CITY OF ALBUQUERQUE

June 24, 2021

RE: **Ziggys Coffee Shop** 5200 Menaul Blvd. NE Grading & Drainage Plan Engineer's Stamp Date: 06/04/21 **Hydrology File: H18D073**

GRADING and DRAINAGE PLAN
SCALE: 1" = 10'-0"

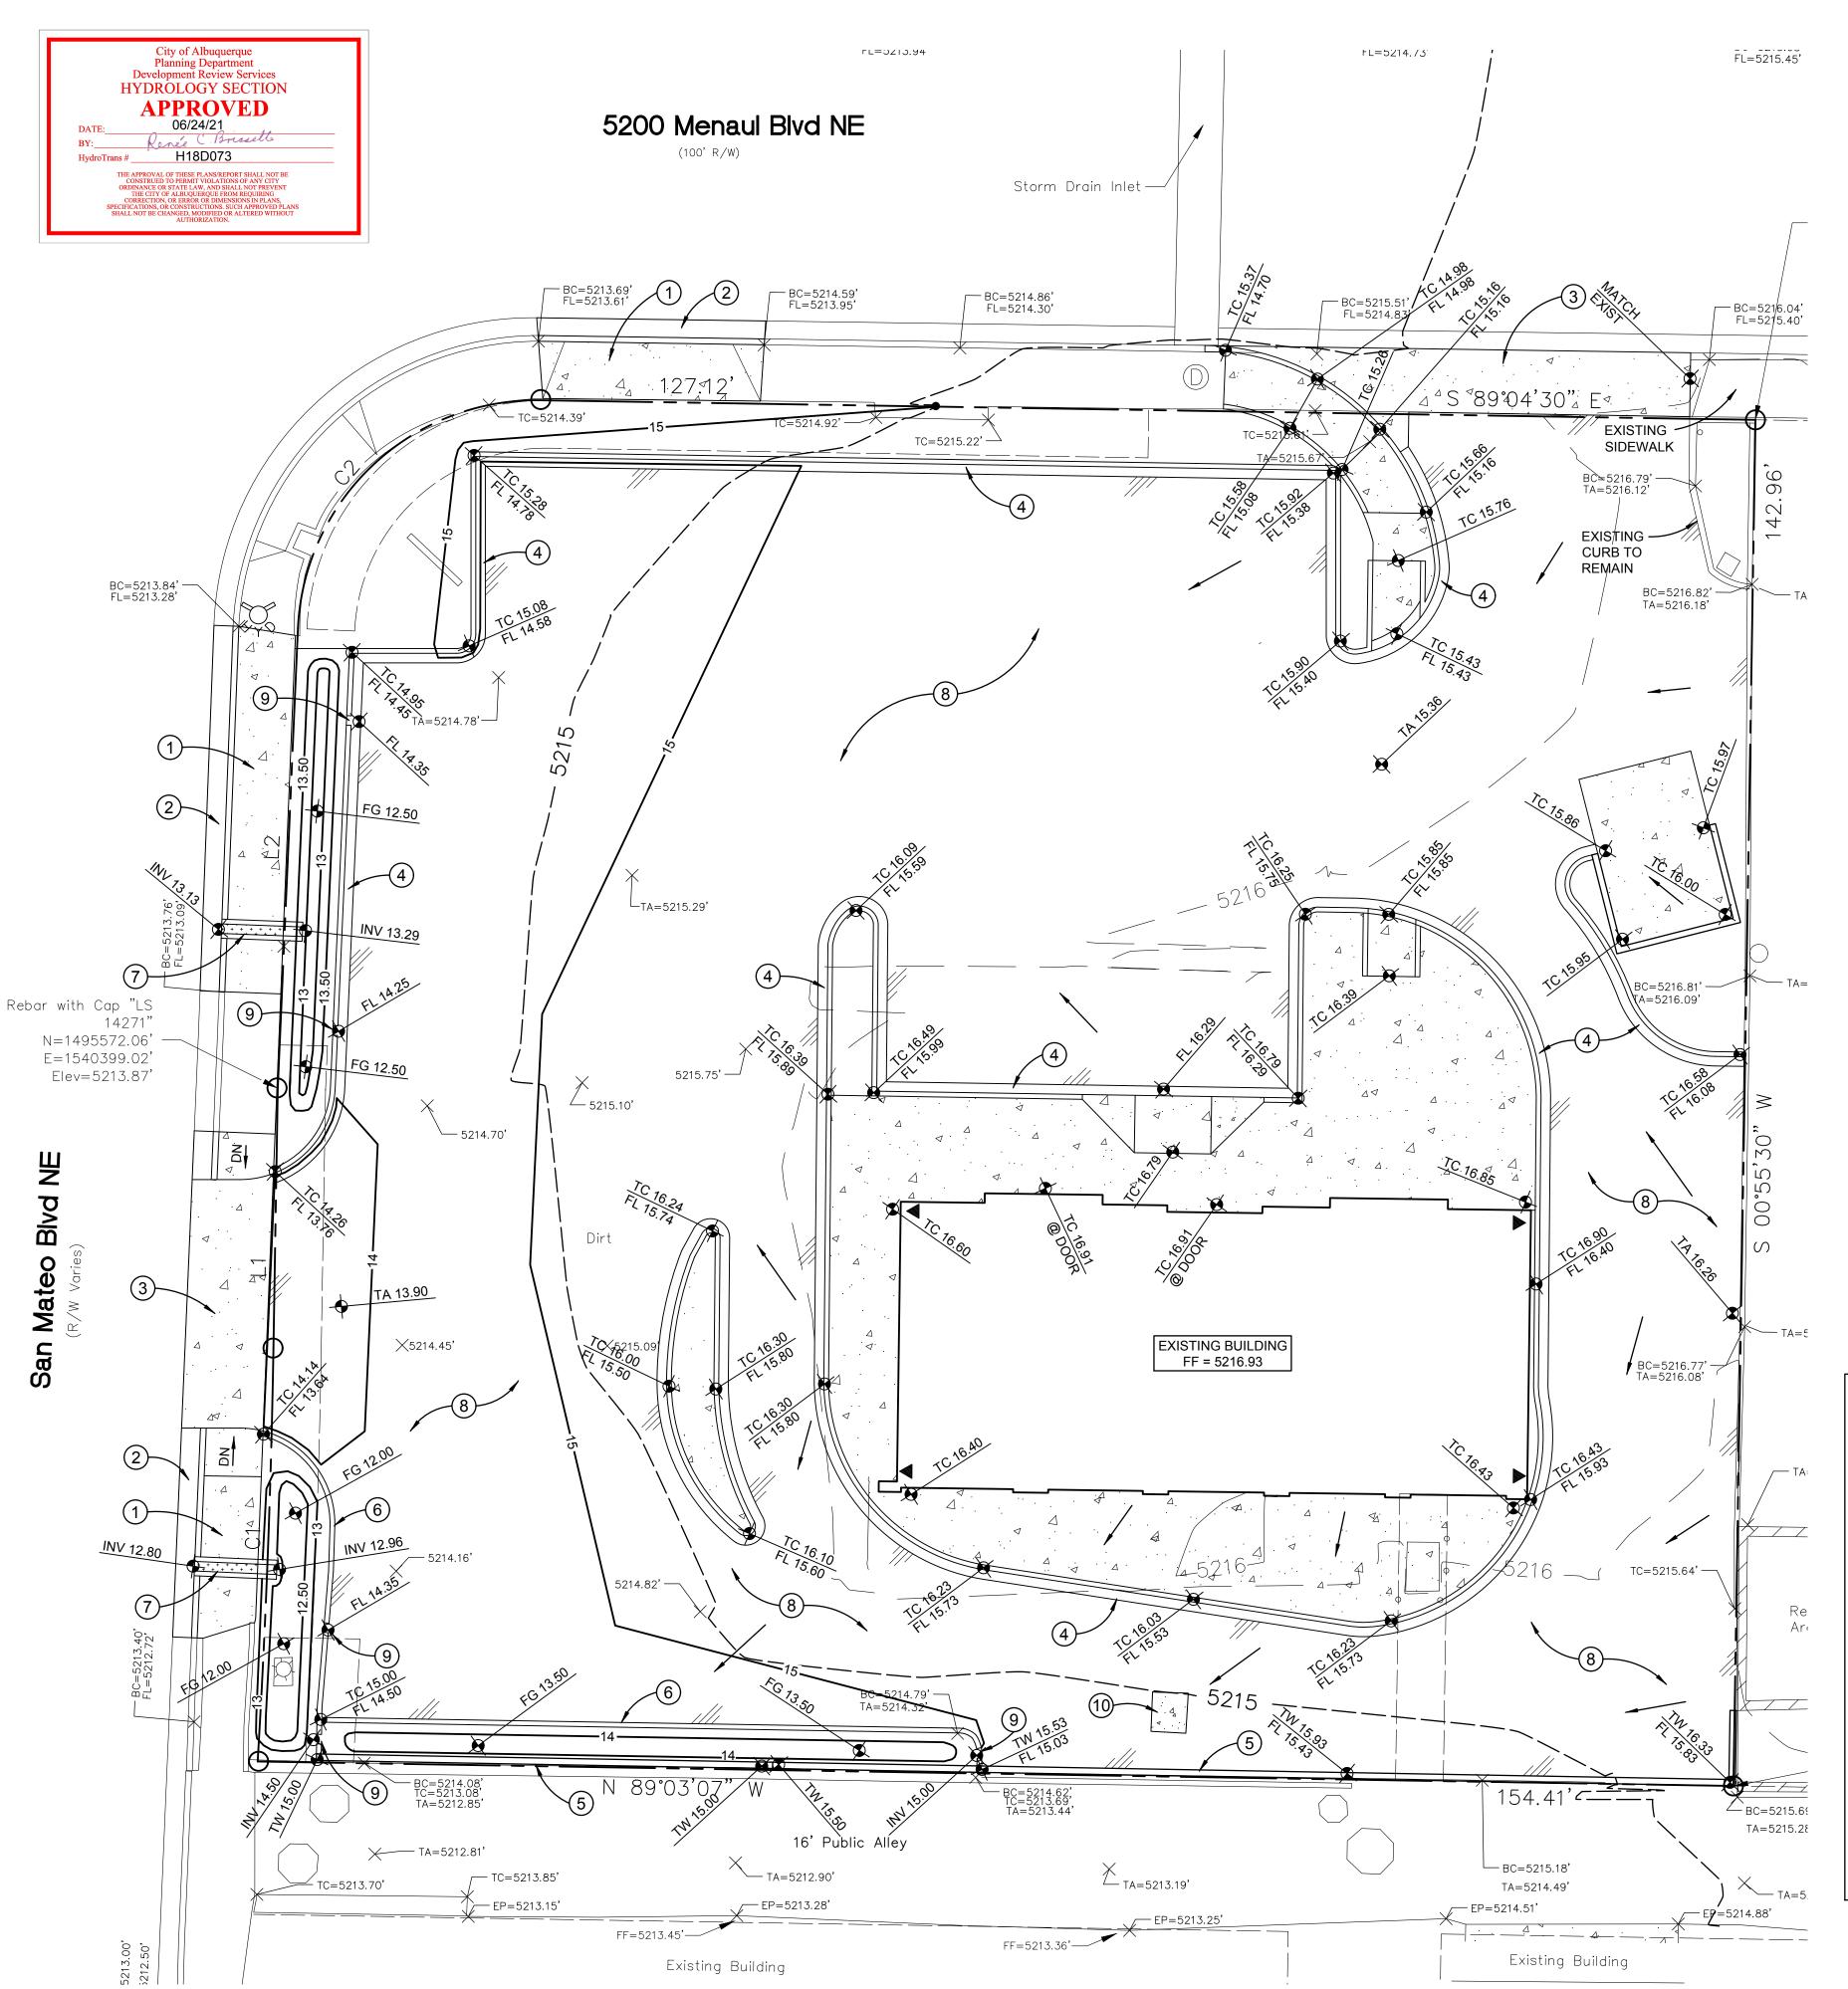
Based upon the information provided in your submittal received 06/04/2021, the Grading and PO Box 1293 Drainage Plan is approved for Building Permit and SO-19 Permit.

Please provide Drainage Covenant for the stormwater quality ponds per Article 6-15(C) of the DPM prior to Permanent Release of Occupancy. There is a recording fee (\$25, payable to Bernalillo County). Please contact me if you have any question pertaining to the Drainage Covenant and email me the Covenant and Exhibit prior to executing it for completeness.

Also, the Payment-in-Lieu of \$ 968.00 must be paid prior to Hydrology's Permanent Release of Occupancy approval. Please follow the instructions:
